PARK PLACE PHASE II SUBDIVISION

MASTER DEVELOPMENT PLAN #748A

Re: Park Place Phase II (Amendment) MDP # 748A

The City Staff Development Review Committee has reviewed Park Place Phase II Master Development Plan amendment, M.D.P. # 748A. Please find enclosed a signed copy for your files. Your plan was accepted, however please note the following:

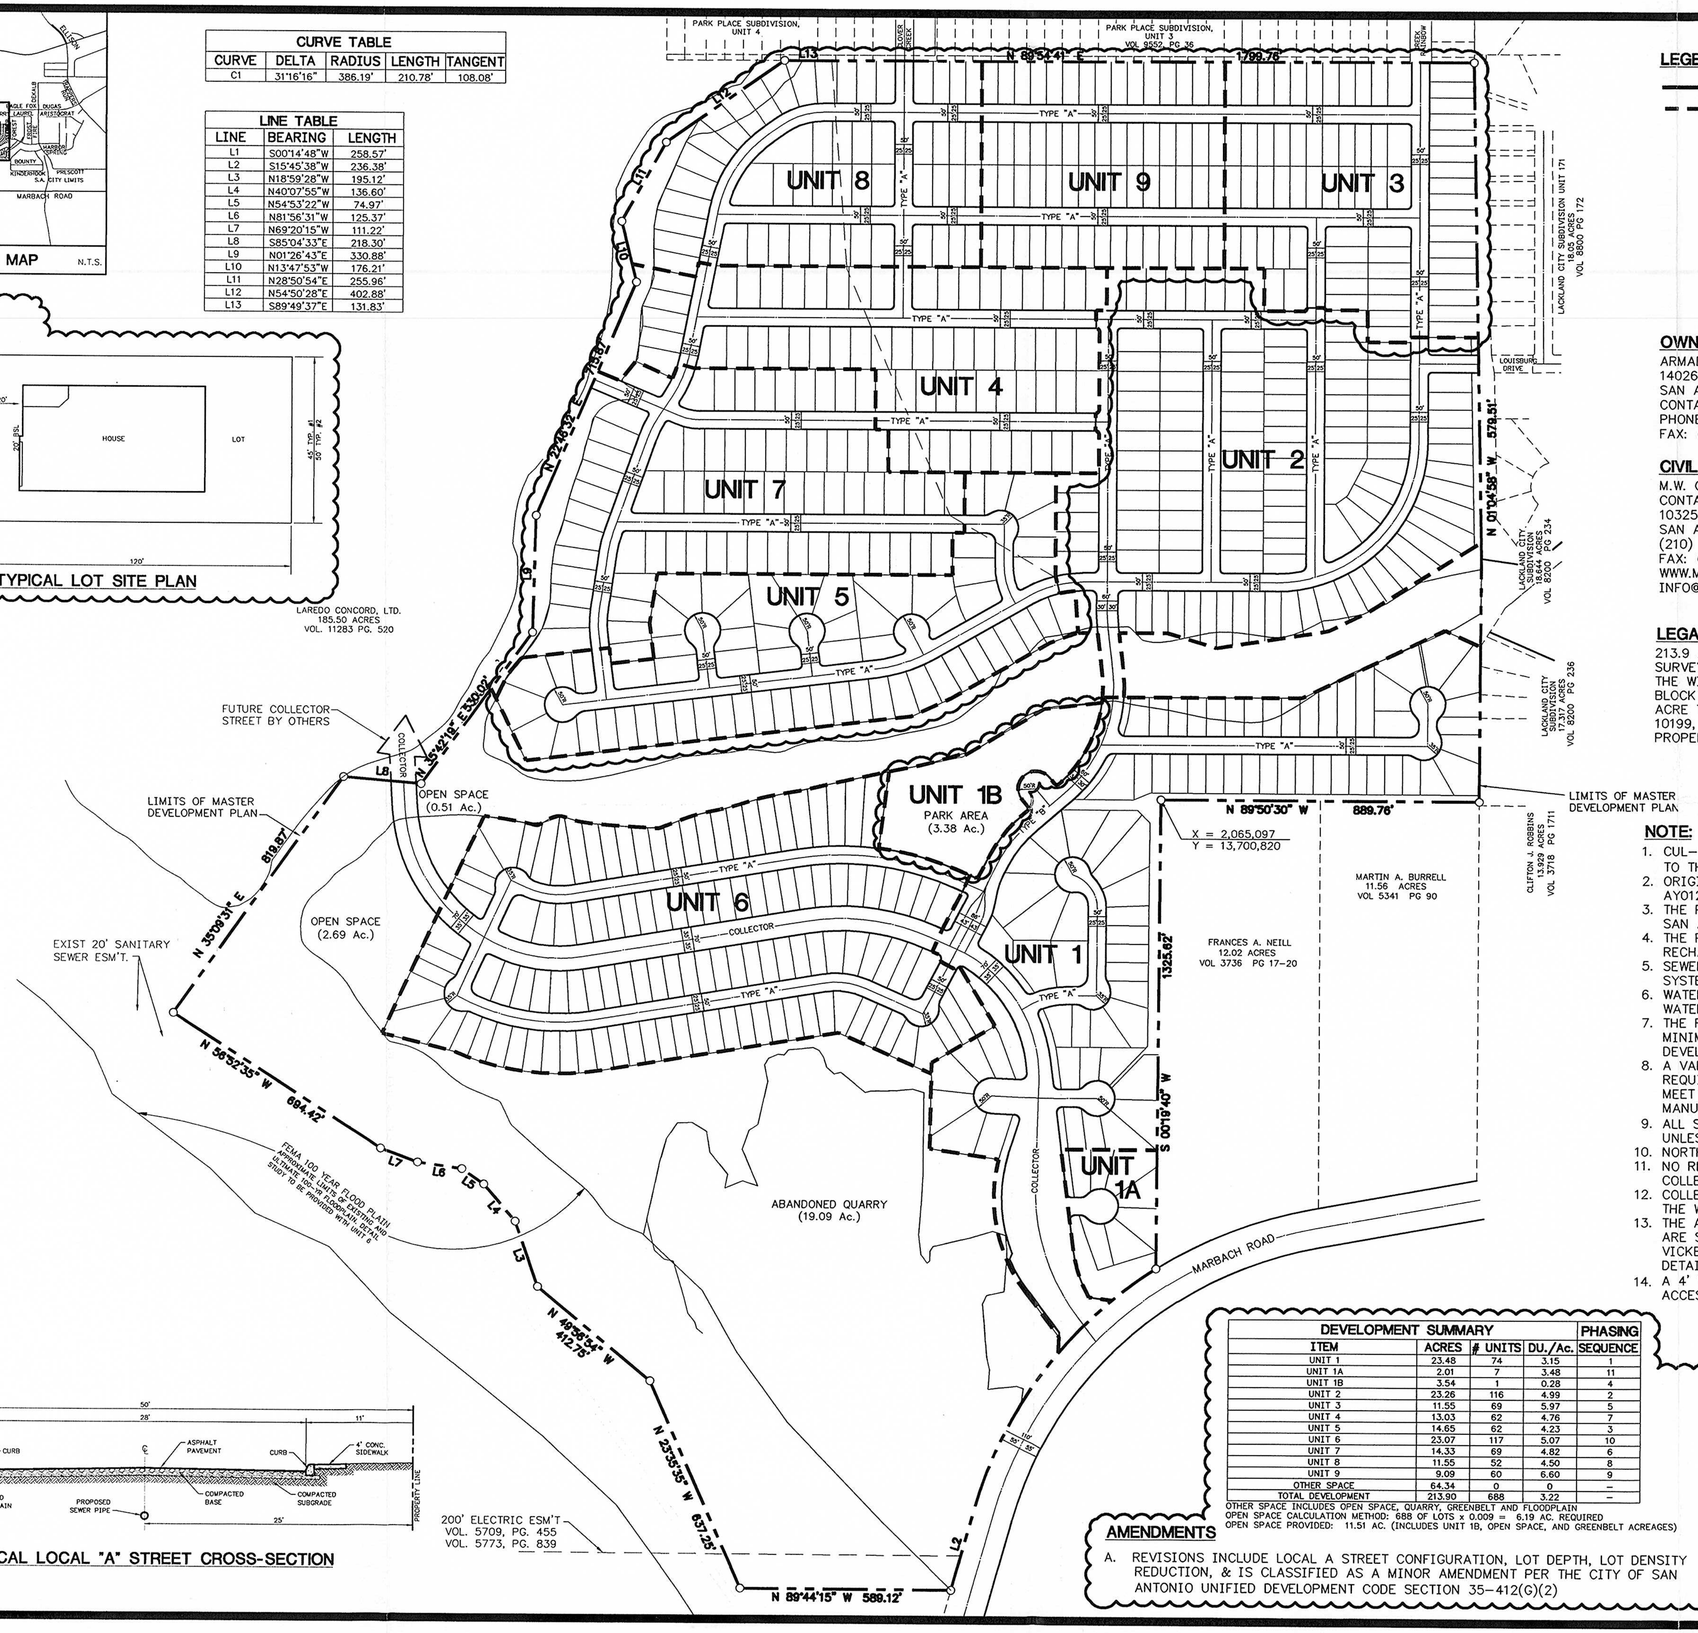
- In consideration of public safety and convenience, excessive grades by reason of topography should be avoided in street layouts and arrangements.
- Any access and R.O.W. issues along state facilities will need to be resolved with the Texas Department of Transportation (TXDOT). For information about these requirements you can contact TXDOT at 615-5814.
- This development will need to comply with tree preservation ordinance #85262. For information about these requirements you can contact Tree Preservation at 207-1111.
- It will be expected that you will plat all of the property depicted in your Master Development Plan (M.D.P) to include floodplains, drainage areas and open space.

- Development Services, TIA Engineering Section has indicated as part of their conditional approval, improvements along the project limits are necessary and shall be provided by the developer, on and before the completion of the Park Place II Development, at no cost to the City of San Antonio:

1. Construction of an internal collector street (Rousseau Road extension) approximately 3, 140 feet in length. The collector shall consist of 70 –feet of ROW and 44- feet of pavement.

2. At the internal collector street (Rousseau Road extension) intersection at Marbach Road, the developer shall design and construct a westbound right-turn lane on Marbach Road (200 feet in length) when this intersection is constructed..

3. At the internal collector street (Rousseau Road extension) intersection at Marbach Road, the developer shall dedicate ROW (200-feet in length) to provide a southbound right-turn lane on the internal collector street (Rousseau Road extension) when this intersection is constructed.

4. The internal collector bridge (all weather crossing) over Medio Creek Tributary, which provides additional access to Park Place II, is required and must be in place prior to completion of the Unit and or Phase adjacent to Medio Creek Tributary.

5. The Local A bridge (all weather crossing) over Medio Creek Tributary shall be designed and constructed under the Phase 5 and or Unit 5. This all weather crossing is a east – west stub out adjacent to the northwest side of the proposed development as shown on the approved Master Development Plan.

6. The additional direct access point from Manor Creek Road (connecting Park Place to Rousseau Road extension) shall be connected once the area west of Park Place and Park Place II is constructed.
